**1012 Richardson Street - Heritage Alteration Permit  
with Variances Application No. 00025 (Fairfield)**

## **Committee of the Whole Report**

**Subject:** **Heritage Alteration Permit with Variances Application No. 00025 for 1012 Richardson Street**

Drawing Title  
**MAIN FLOOR PLAN**

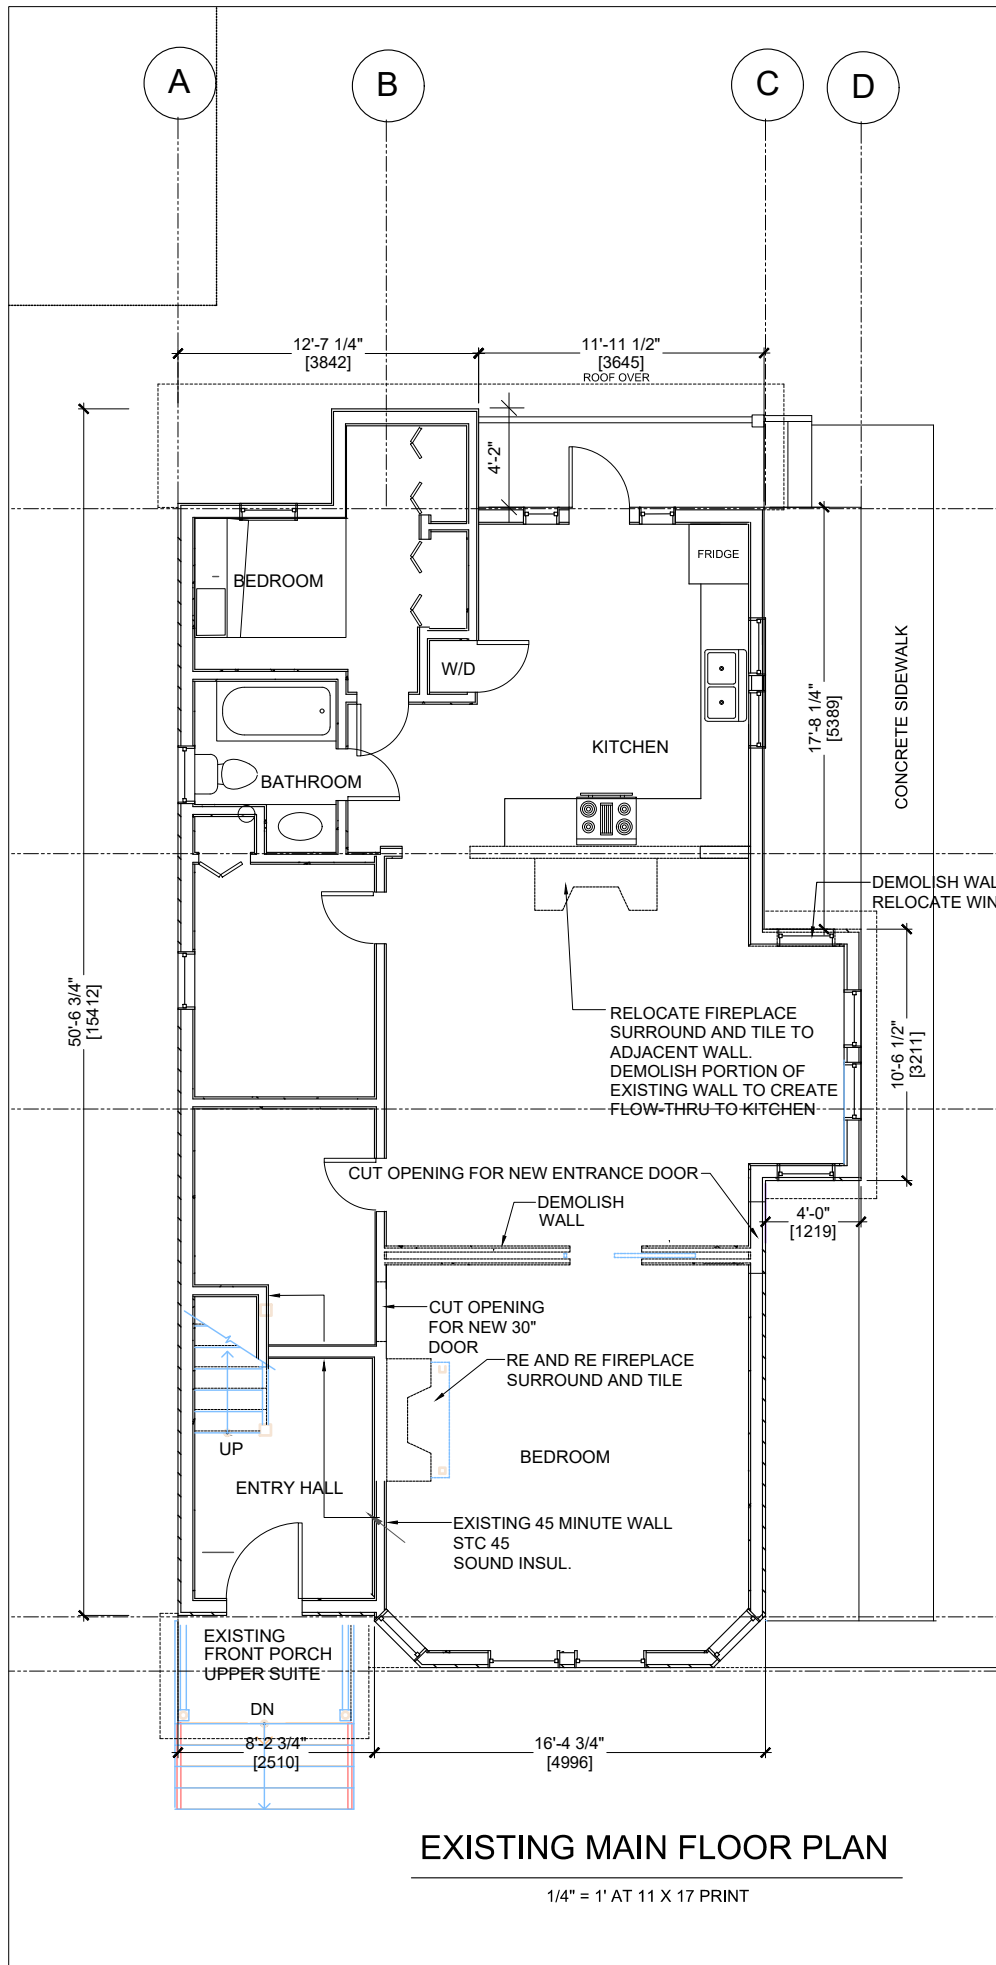
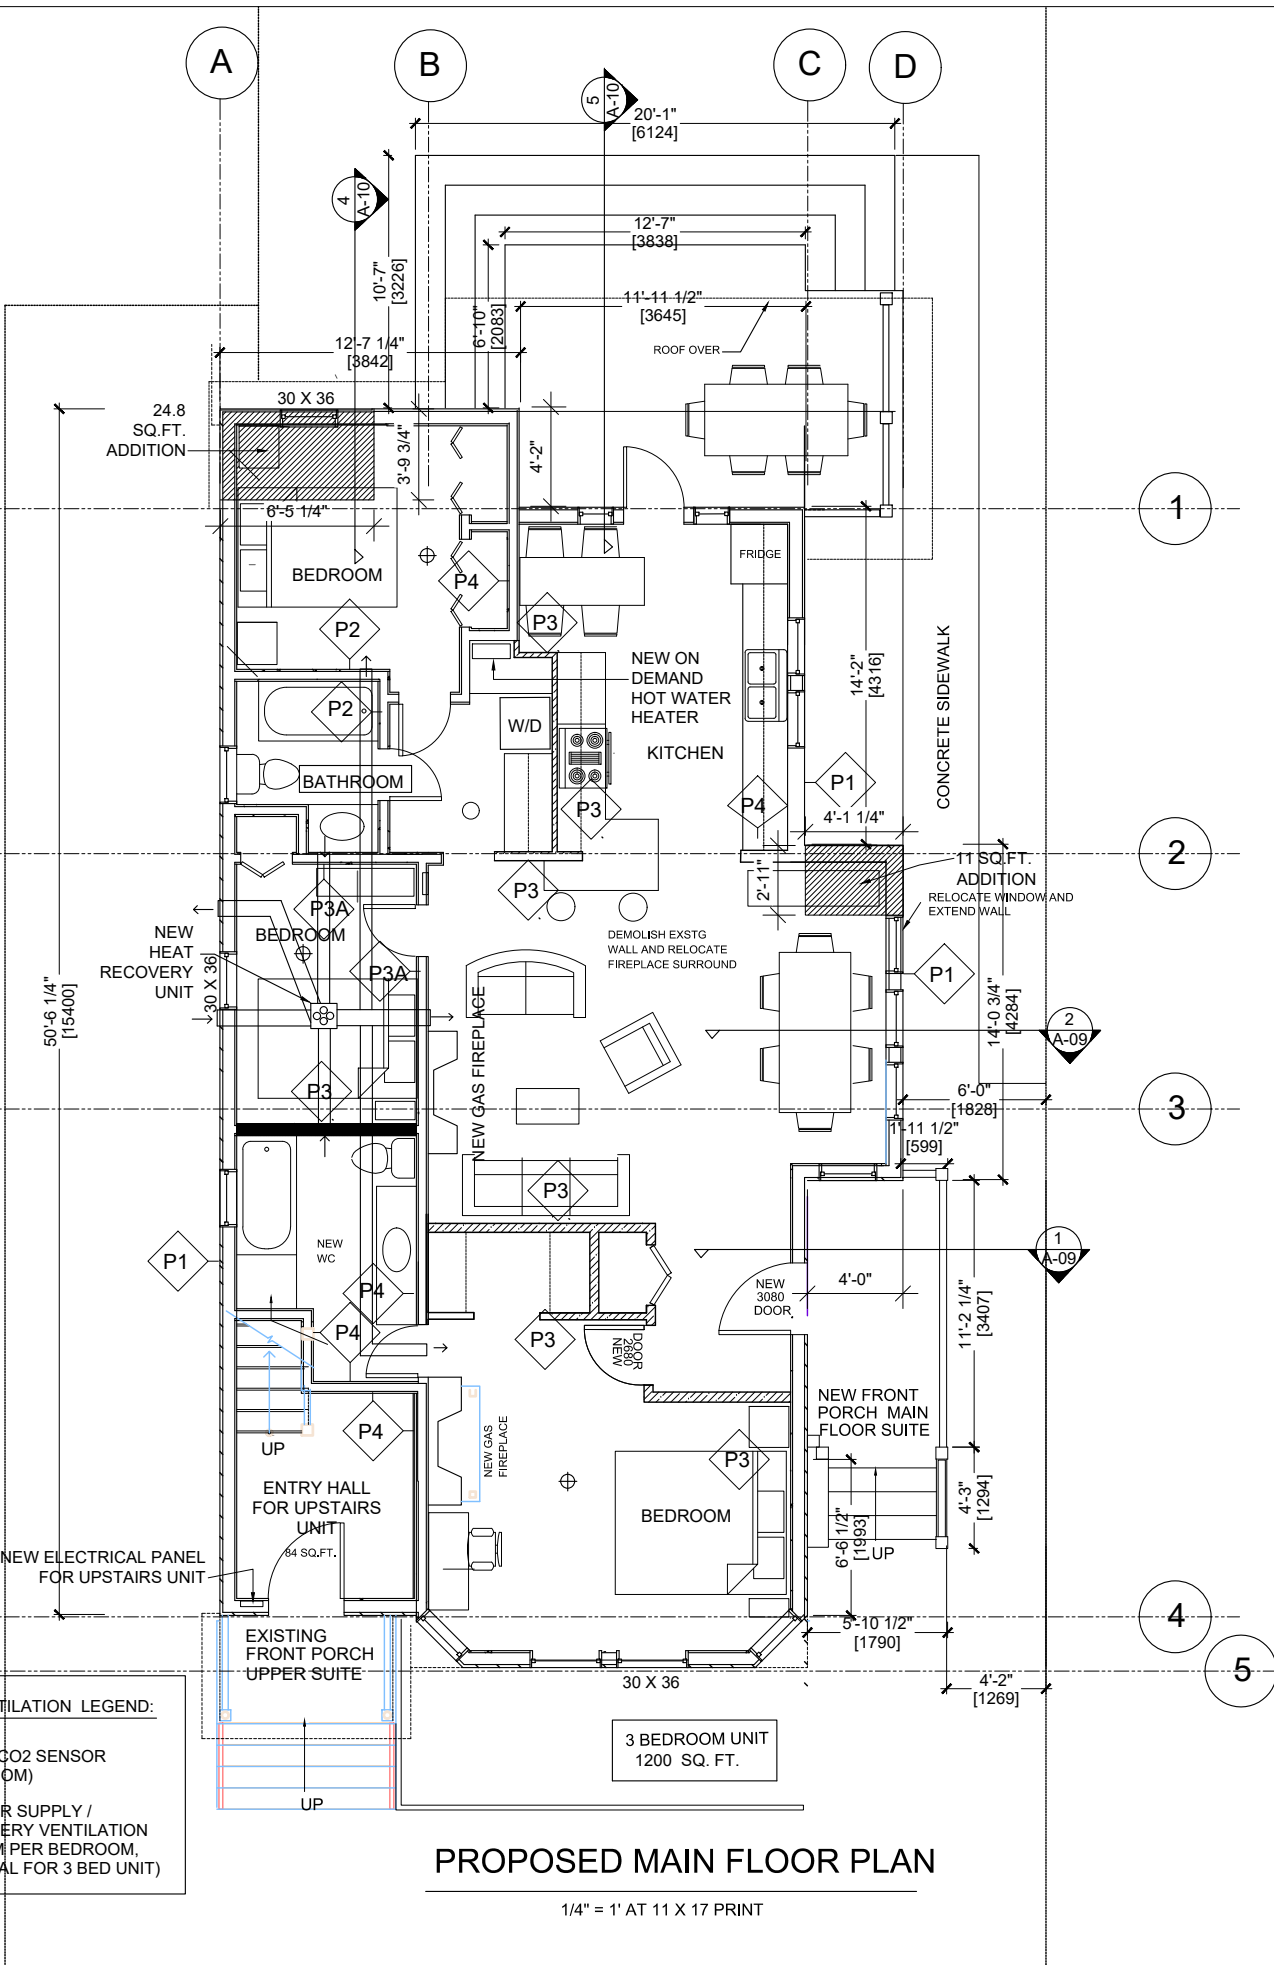
Changes to the rear elevation of the building are also minor and include the enlargement of a rear patio, a corresponding widening of the roof overhead and a 21-square foot addition to the ground floor at the northwest corner of the house. The sloped roof would be extended overtop of this addition. An existing landing with a decorative balustrade would be removed. The rear landing is not identified as a character-defining element of the house and removal does not detract from the overall arrangement of features on the rear of the house. The addition at the northwest corner would be finished in the same cladding as the remainder of the house and extends an existing square bump out from the middle of the rear ground floor to the corner of the house, which squares off the floor plan.

WEST ELEVATION

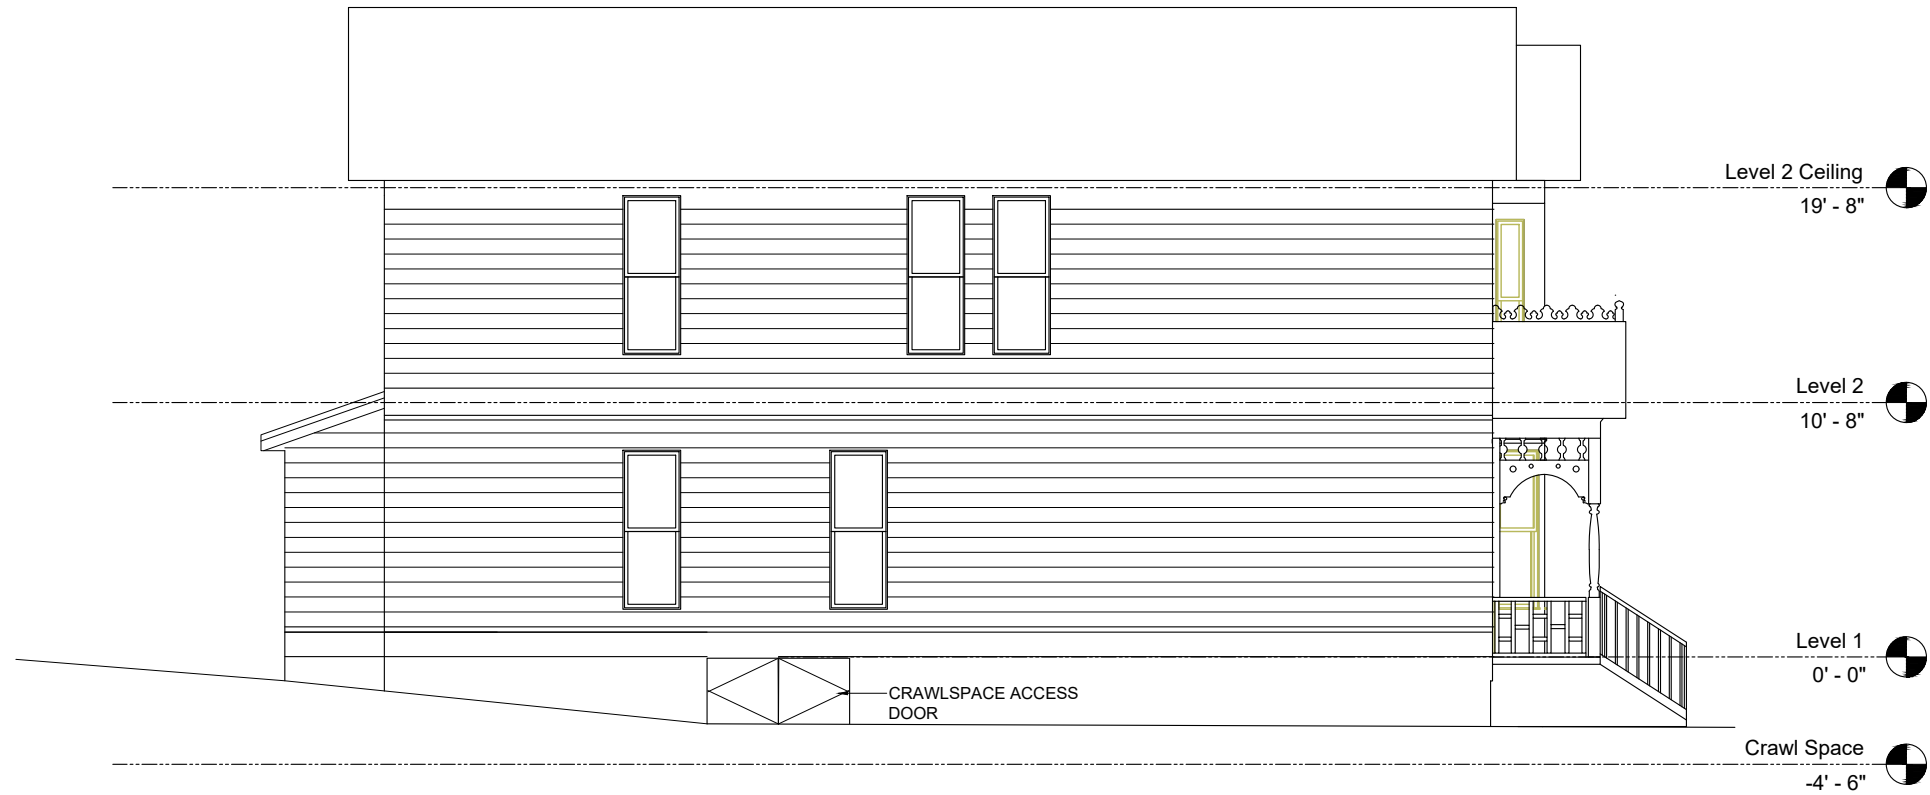
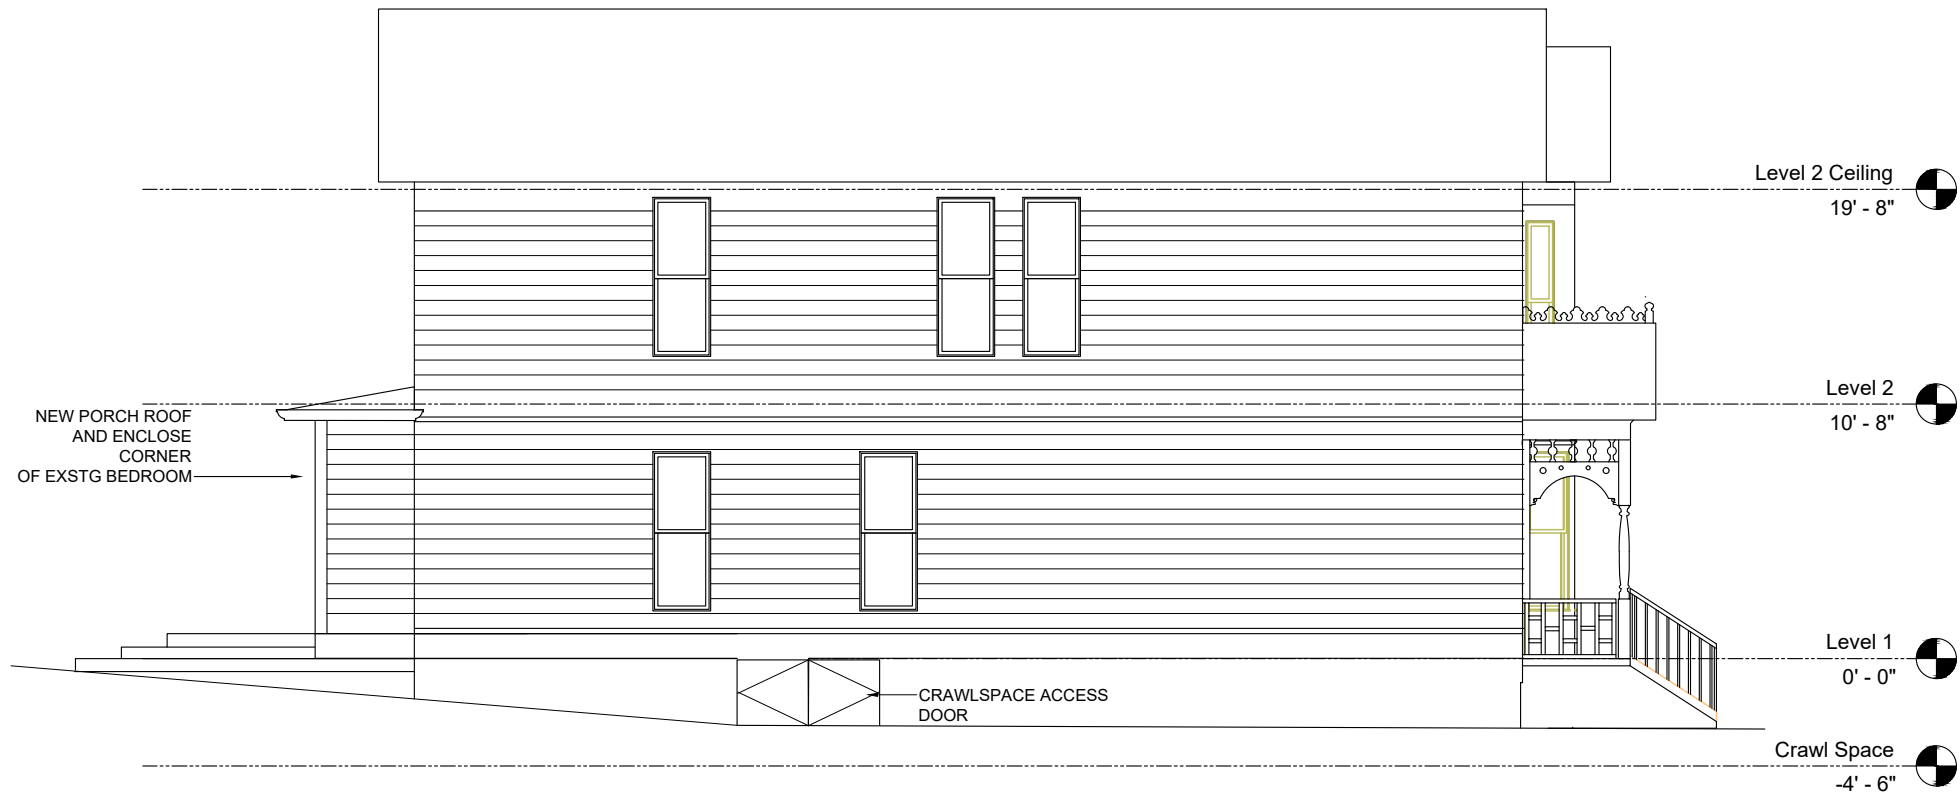
Four of the proposed variances relate to reduced setbacks. The addition at the northwest corner of the building is flush with the existing west elevation, however a variance is required to allow it to achieve the same non-conforming 2.58m side yard setback as the remainder of the building instead of the standard requirement of 3.0m. This addition also triggers a technical rear yard setback variance because the side property line has a 90-degree jog at this location. The setback is measured to the jogged portion of the lot line, instead of to the further rear yard property line.

A combined side yard variance is needed to reduce this requirement from 4.5m to 3.85m because the existing west side yard setback of 2.58m does not conform with the Zoning Bylaw standard of 3.0m and the bay window will decrease the east side yard setback to 1.27 metres.
